ADDENDUM # 4

To: File 1903-910-65-4901

IFB for: Castle Point Exterior Renovations and Site Improvements

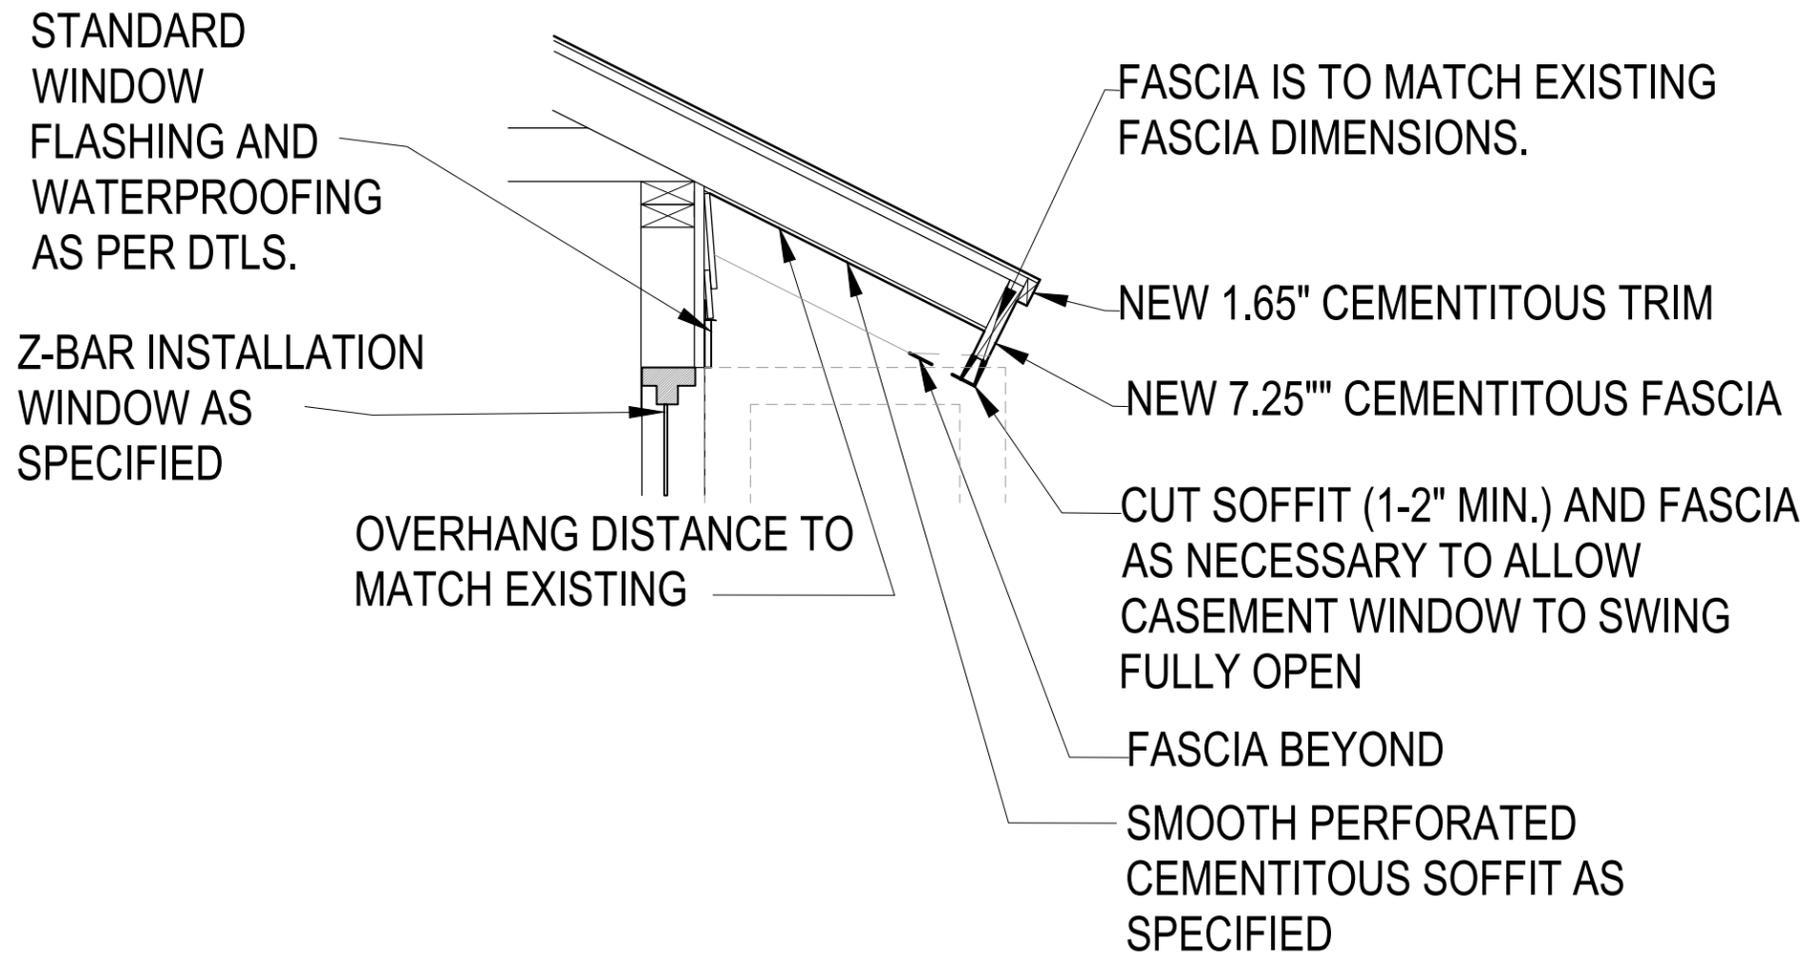
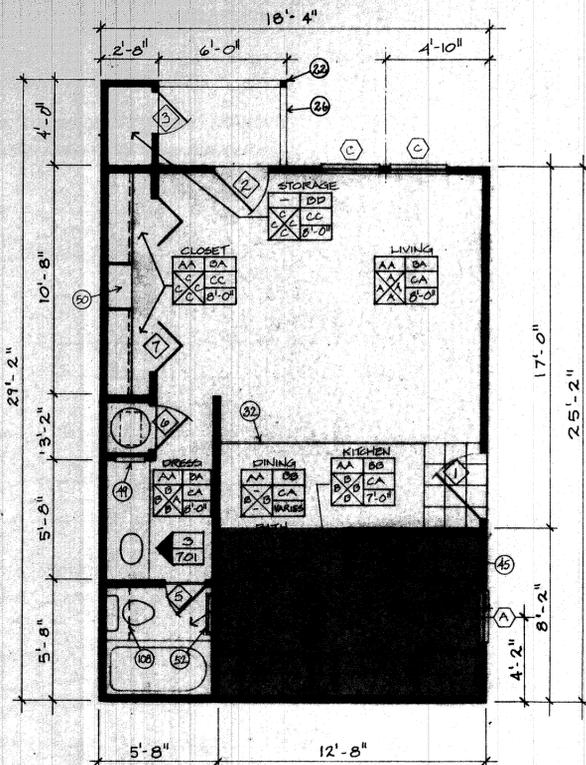
If windows do not open fully, contractor is to cut the fascia and soffit as necessary to allow the casement windows to fully swing open. (See attached detail and plan locations for casement windows.) All windows may not need to have the fascia/soffit cut. Please field verify

Window type "C & E" in bedroom only are to have casement windows that swing open. These windows are located at: buildings # 3, 5, 7, 11, 15, 16, 17

Sheet no: **A4.01**

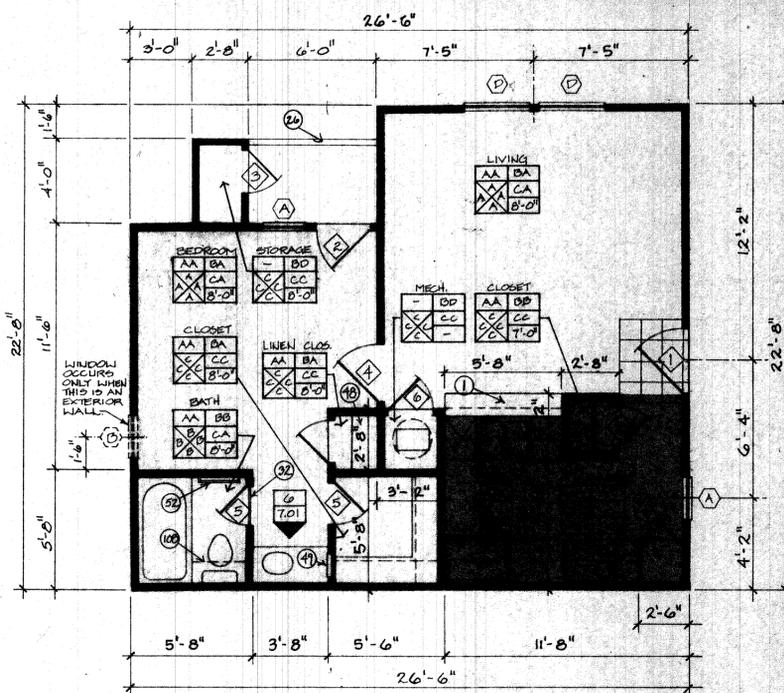
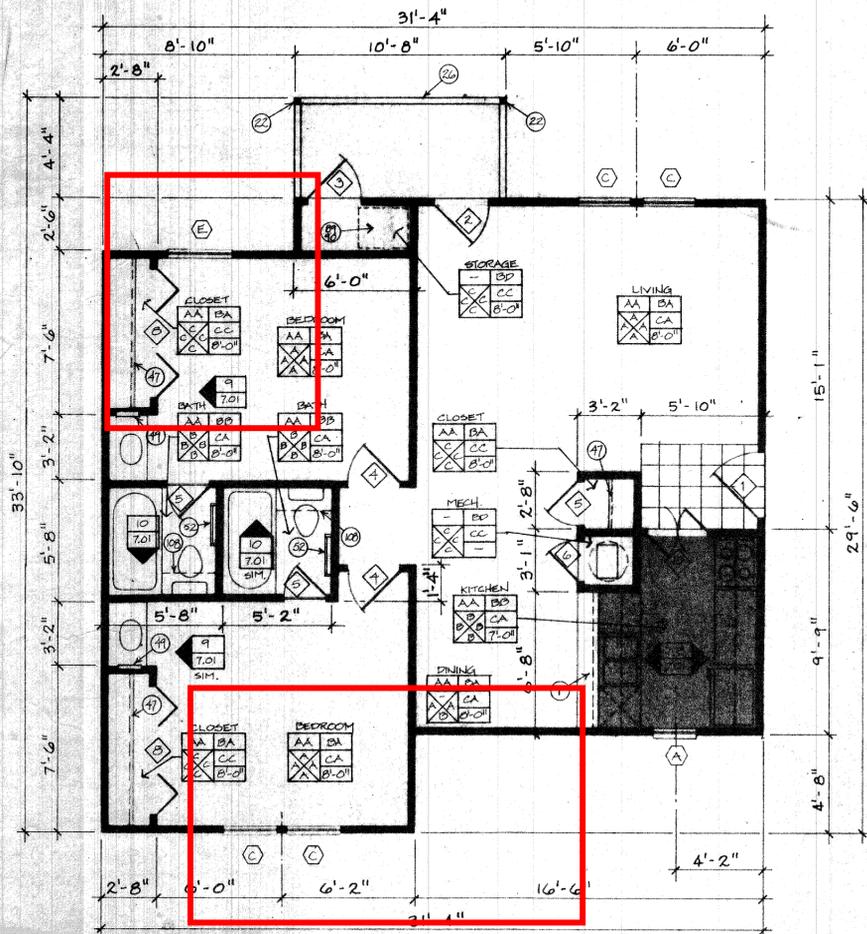
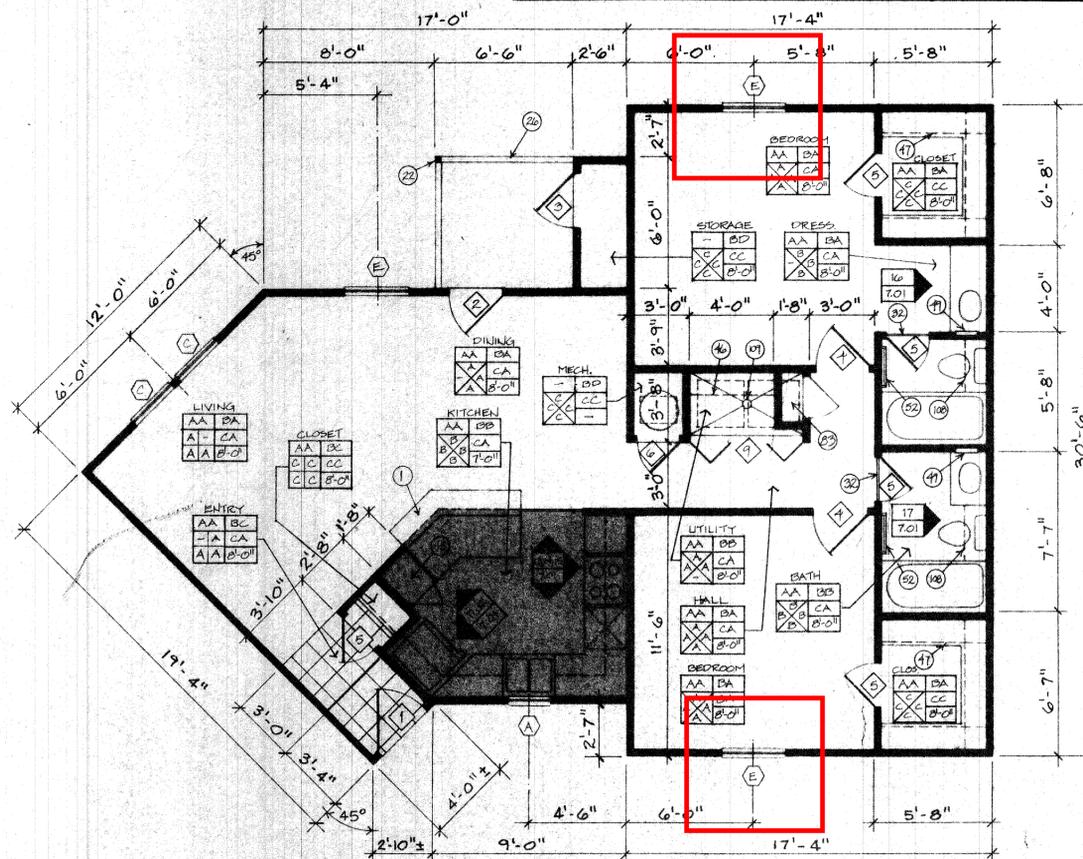
Question 1: We were walking the buildings in regards to the bedroom windows meeting egress and noticed the 32"x36" windows do not meet the 5.7 sq ft opening for egress nor does it meet the 44" from the floor. The windows are measuring 47" from the floor and that does not meet egress code. How will the architect address?

Question 2: Casement clearance with existing roof eaves - On building type IV and V there is an existing roof eave that extends out over the top of the window "pairs" on the building. I checked it out today and took some pictures and video. The challenge we are running into is that the existing fascia is going to interfere with a casement window opening 90 degrees at that location. Based on my rough calculations it is probably less than 1" for clearance, but the window will have a 26" projection and it will still not permit a full opening.

Answer 1: Egress windows are not need in bedrooms with doors to the balconies. All bedrooms with balconies that do not have doors will need to meet the required means of egress for window openings.

All egress windows shall have a sill height of 44", per the windows with 47". Based on the 2015 IEBC 406.3. We are grandfathered from having to have a lower sill height, as long as we meet the following parameters. Please research and understand all the additional requirements regarding replacement windows.
